Name: Eagle Crest – Preliminary Plan – Lot 16 of Block 9 – Ridges #6

FILE: #20-94
DATE: February 17, 1994
STAFF: Kathy Portner
REQUEST: Preliminary Plan--Eagle Crest
LOCATION: Lot 17, Block 9, Filing 6, The Ridges
APPLICANT: Sidney Gottlieb

RESPONSE TO REVIEW COMMENTS

FILE: #20-94(2)
DATE: July 19, 1994
STAFF: Kathy Portner
REQUEST: Preliminary Plan--Eagle Crest
LOCATION: Lot 17, Block 9, Filing 6, The Ridges
APPLICANT: Sidney Gottlieb

ENTRANCE DETAIL

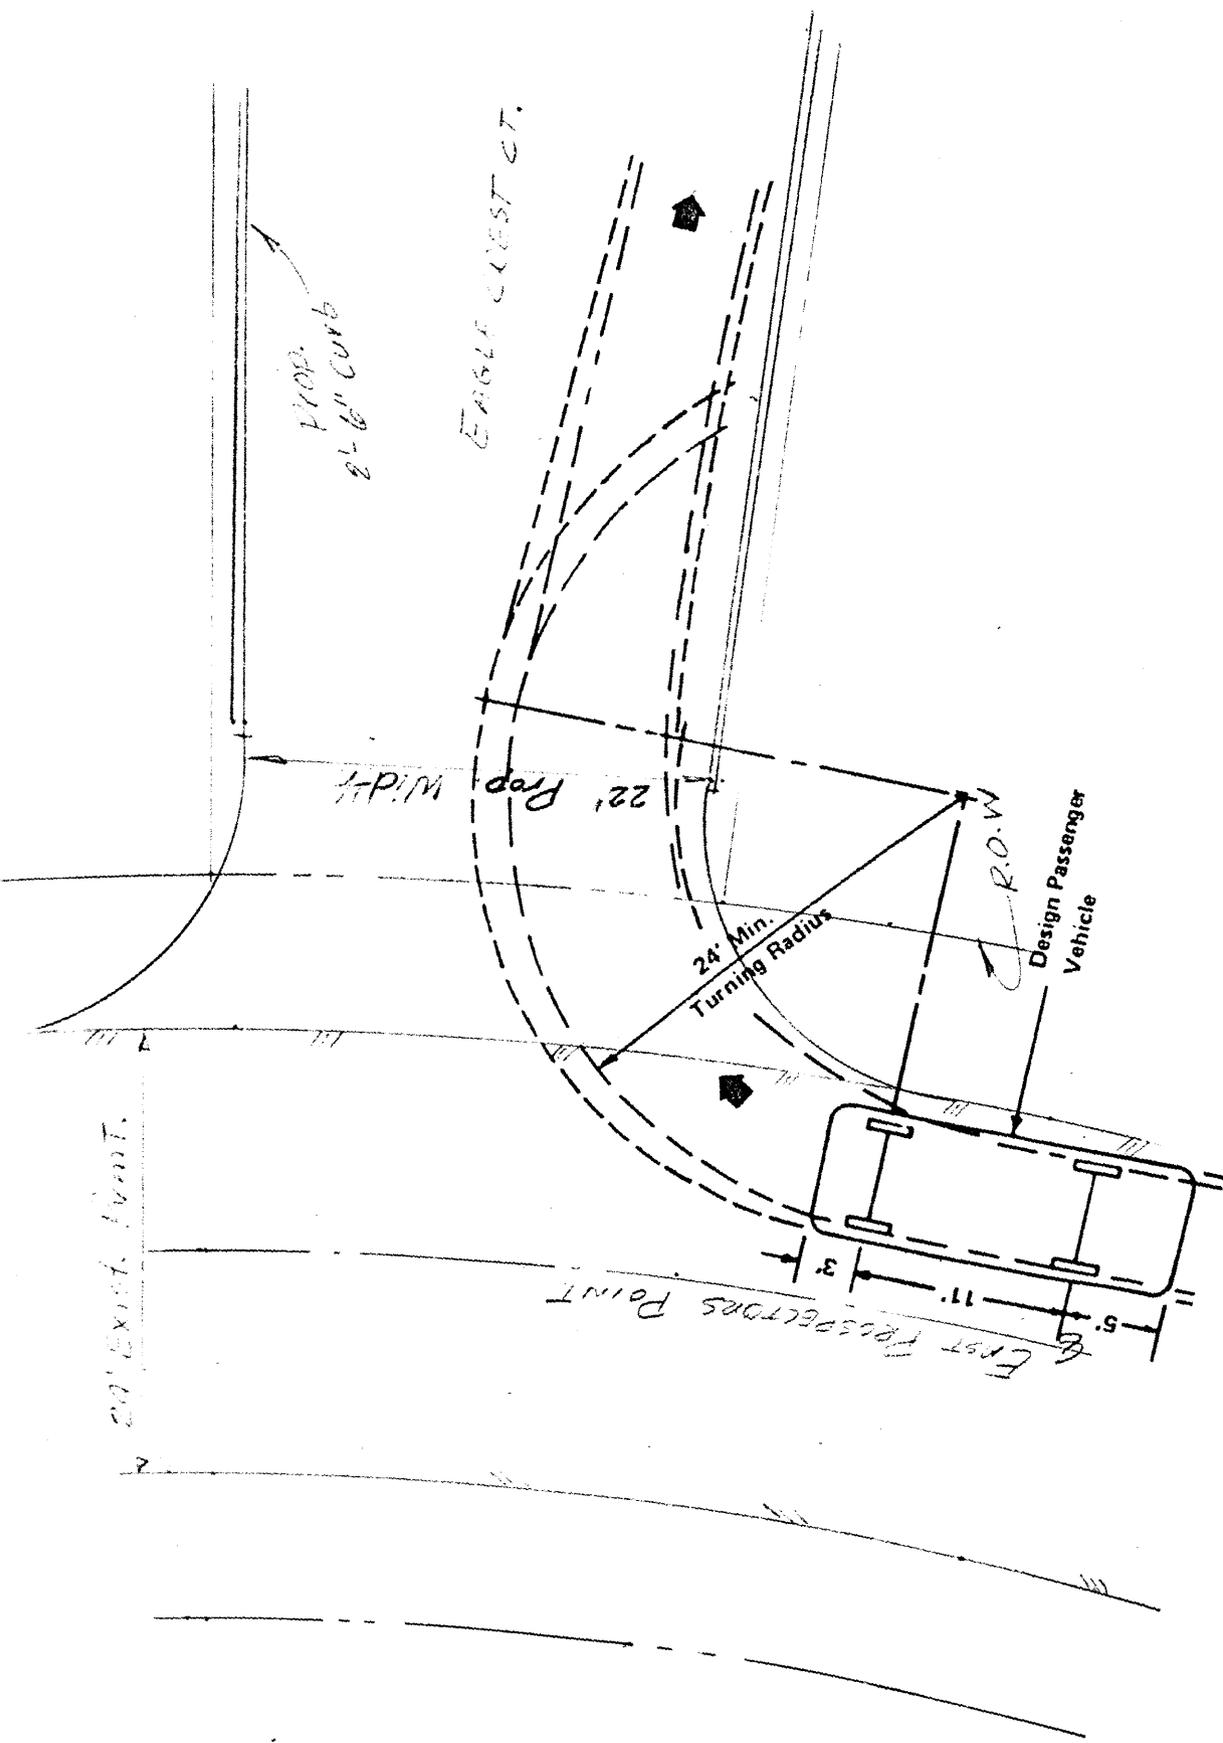
City standards require 44' ROW and 28' pavement width. The entrance does not meet this. A minimum 20' radius is required at the intersection. What will the 12" CMP on Ridges Blvd. be replaced with? How will the City access manholes on the slope? A drainage easement across the open space will be required. What happens to the pedestrian path? Does it end abruptly as shown on the plans?

1. Attached is a the proposed pedestrian circulation plan.
2. Attached is a detail of the intersection geometry at Eagle Crest Court and Prospector Point.
